Attachment I to JPN-93-028

PROPOSED TECHNICAL SPECIFICATION CHANGES  
REVISION OF TABLE 4.7-2

New York Power Authority

JAMES A. FITZPATRICK NUCLEAR POWER PLANT

FIGURE 1

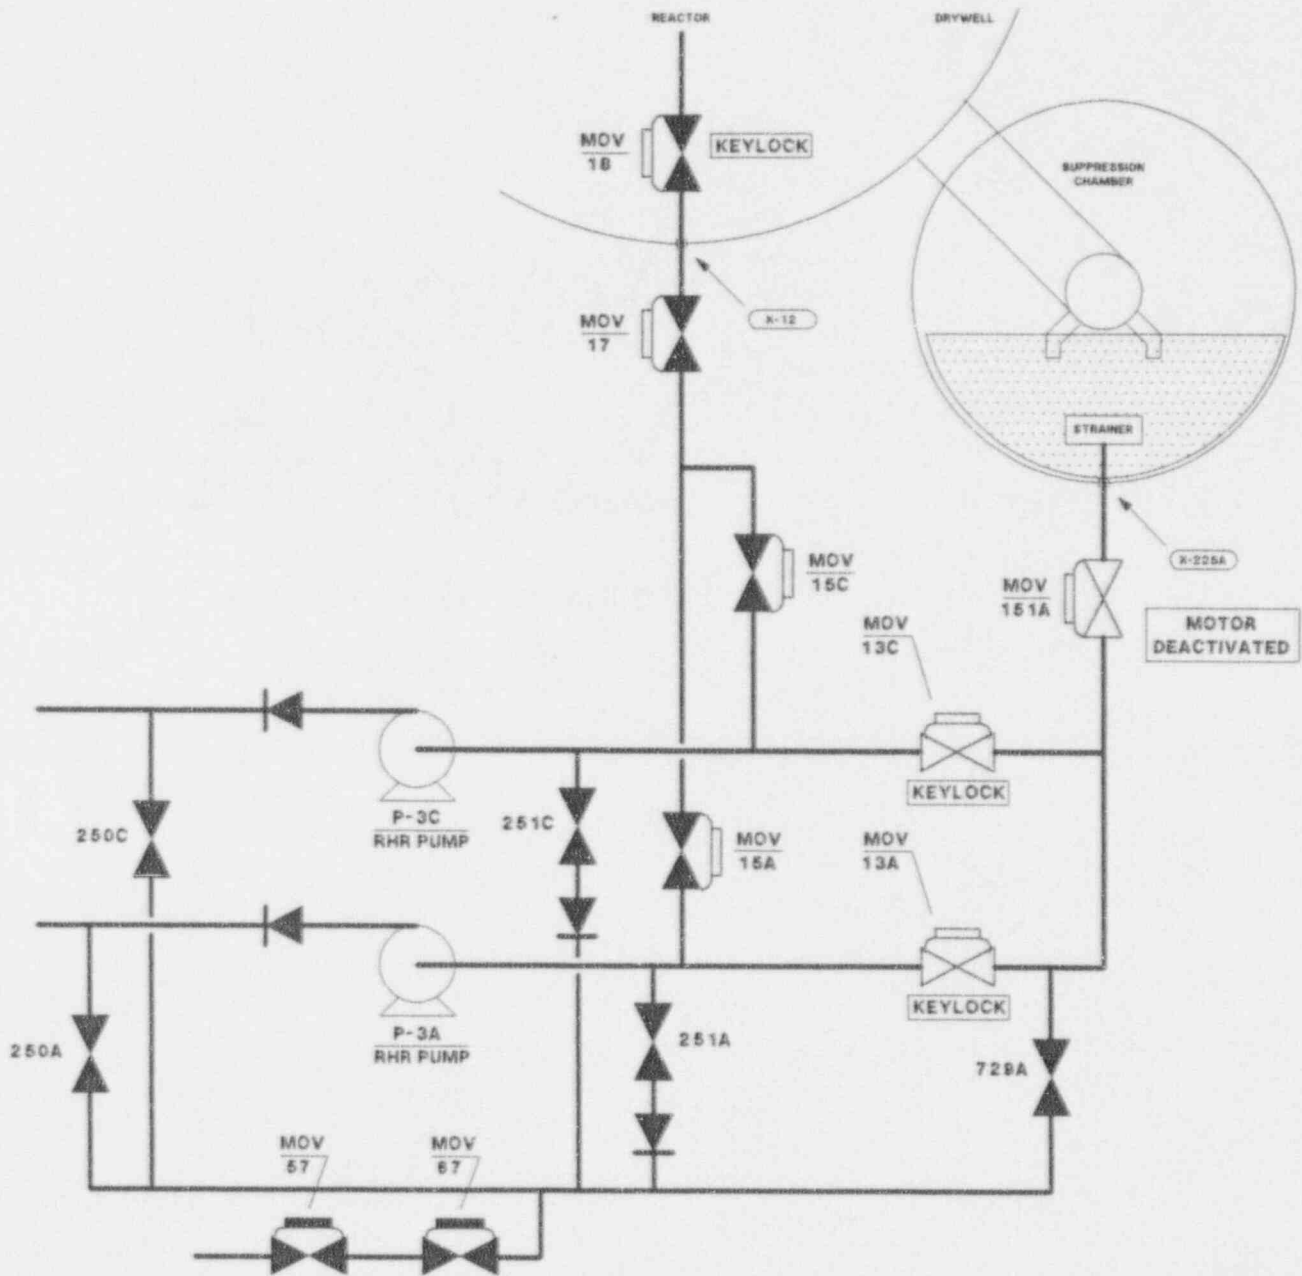
10MOV-57 and 10MOV-67 receive the same Primary Containment Isolation Signals (PCIS) as shutdown cooling suction containment isolation valves (CIV) 10MOV-17 and 10MOV-18. These valves are on a line (Figure 1) that connects the Residual Heat Removal (RHR) system to the radwaste system to provide drain down capability and are normally closed. Additional isolation is provided by closed manual isolation valves, i.e., 10RHR-250A&C, 10RHR-251A&C, and 10RHR-729A, located upstream of 10MOV-57 and 10MOV-67. The presence of PCIS signals implied that valves 10MOV-57 and 10MOV-67 performed a safety related purpose.

A safety evaluation (Reference 2) was performed to determine if these valves were CIVs as defined by the FitzPatrick licensing basis. The safety evaluation concluded that 10MOV-57 and 10MOV-67 were incorrectly classified as CIVs. PCIS signals activate 10MOV-57 and 10MOV-67 to automatically isolate this line to prevent a loss of water from the lines between the RHR pumps and 10MOV-17 after 10MOV-17 has been closed and to prevent flow diversion on Emergency Core Cooling System (ECCS) actuation.

During the evaluation process of determining if 10MOV-57 and 10MOV-67 were CIVs, it was noted that the drain down lines for both the "A" and "B" sides each included a manual isolation valve, i.e., 10RHR-729A upstream of 10MOV-67 on the "A" side and 10RHR-729B upstream of 10RHR-253 on the "B" side. The safety evaluation (Reference 2) which determined that 10MOV-57 and 10MOV-67 are not CIVs also concluded that isolation of the "A" side RHR drain down line branching out of penetration X-225A leading to the radwaste system is performed by 10RHR-729A (see Figure 1). Isolation of the RHR to radwaste system "B" side drain down line is similarly handled by 10RHR-729B for penetration X-225B.

Delete valves "10MOV-57" and "10MOV-67" for containment penetration X-225A.

Add valve "10RHR-729A" for containment penetration X-225A.

Add valve "10RHR-729B" for containment penetration X-225B.

FIGURE 2

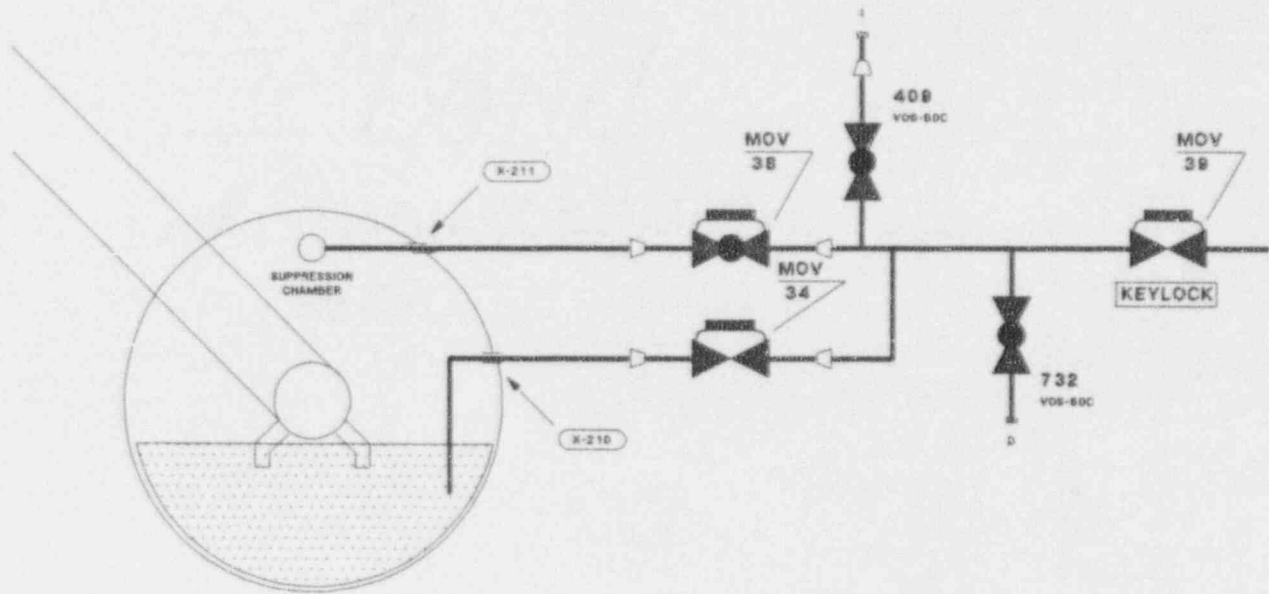
The changes to page 213 clarifies that CIVs 10MOV-34A and 10MOV-34B are exempt from Type C (local leak rate) testing by deleting the references to their inclusion in the testing of penetrations X-211A&B, respectively. These valves are on lines which terminate inside the torus below the low torus water level (see Figure 2). Technical Specification 4.7.A.2.c.(3.) specifically exempts "Valves, which are sealed with fluid from a seal system, such as the liquid in the suppression chamber ..." from Type C testing.

Because of the configuration of penetrations X-210 and X-211, valve 10MOV-34 must be closed to test valves 10MOV-38 and 10MOV-39. In the test configuration, all three valves are closed to create a test volume. During the test, this volume is pressurized and the total leakage from the volume is measured as a function of time. Because 10MOV-34 is exempt from a Type C Test, the leakage from the test volume is attributed to valves 10MOV-38 and 10MOV-39. This is conservative because it over estimates the leakage through these two valves.

For containment penetration X-210A, page 213, in the "Local Leak Rate Test Performed" column, delete the phrase:

"Valve 10MOV-34A is tested during the Type C test of Penetration X-211A."

For containment penetration X-210B, page 213, in the "Local Leak Rate Test Performed" column, delete the phrase:

"Valve 10MOV-34B is tested during the Type C test of Penetration X-211B."
